51 Centre Road, Vermont

Traffic Engineering Review

This report has been prepared in response to Department of Transport and Planning (DTP) request for additional information, specifically to address the comments listed below:

Drawing Title ST JAMES PRIMARY SCHOOL, VERMONT VEHICLE SITE ACCESS SWEEP PATH ANALYSIS		
Designed CM	Approved JD	Melway Ref 63 C2
Project Number 230488	Drawing Number SPA100	Revision A

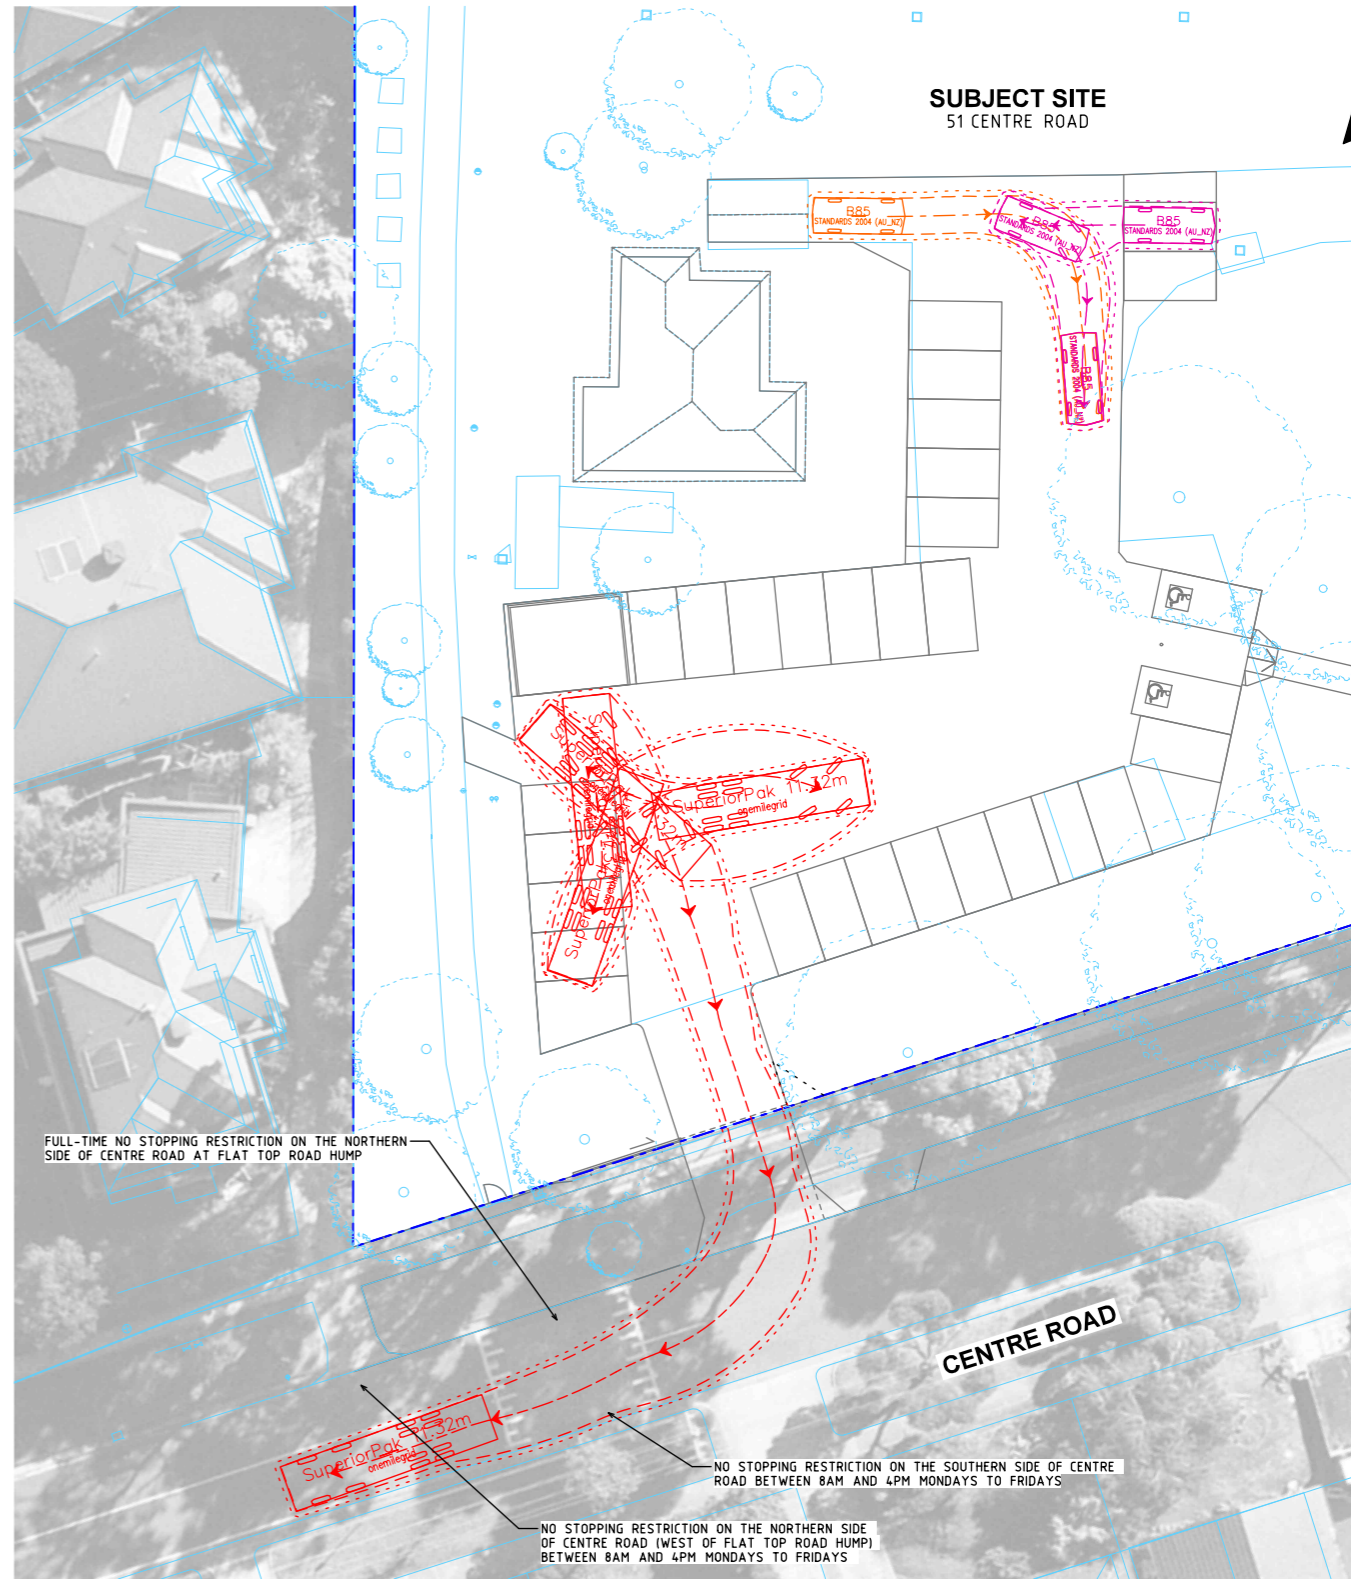
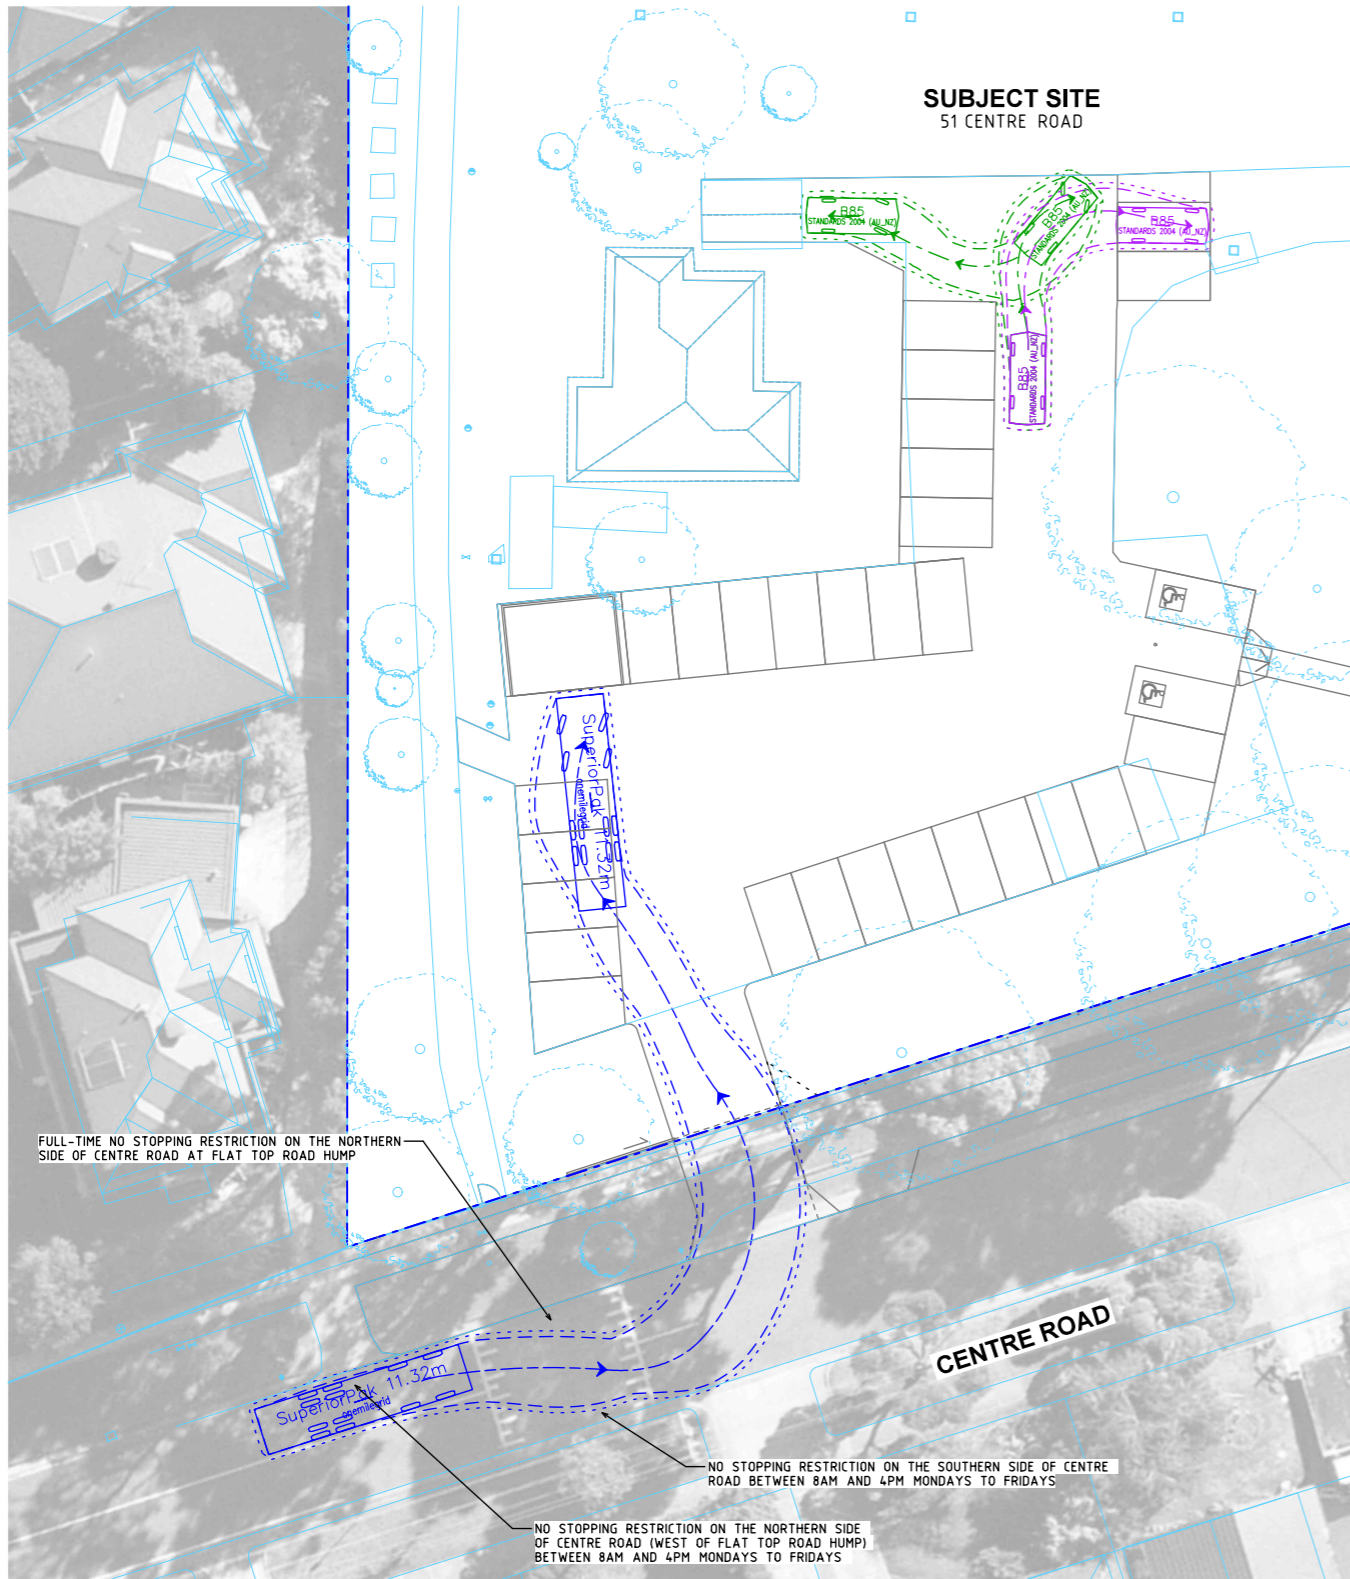
Comment	Response
Confirmation as to whether the proposed car park layout is feasible and safe.	onemilegrid are satisfied with the proposed car park layout.
A swept path assessment confirming that key spaces are suitably accessible and revised waste collection arrangements remain appropriate for the class of collection vehicle.	Swept path diagrams are provided attached demonstrating access to critical car spaces. It is noted that all spaces are designed in accordance with the Planning Scheme requirements. Consistent with the existing arrangements, forwards-in, forwards-out access for waste vehicles may be readily provided within the on-site car park. It is noted that five car spaces must remain empty to facilitate this in a single corrective manoeuvre, and thus waste collection should occur outside of busier periods within the car park. Swept path diagrams are provided illustrating potential waste collection with an 11.32m front loader waste truck.
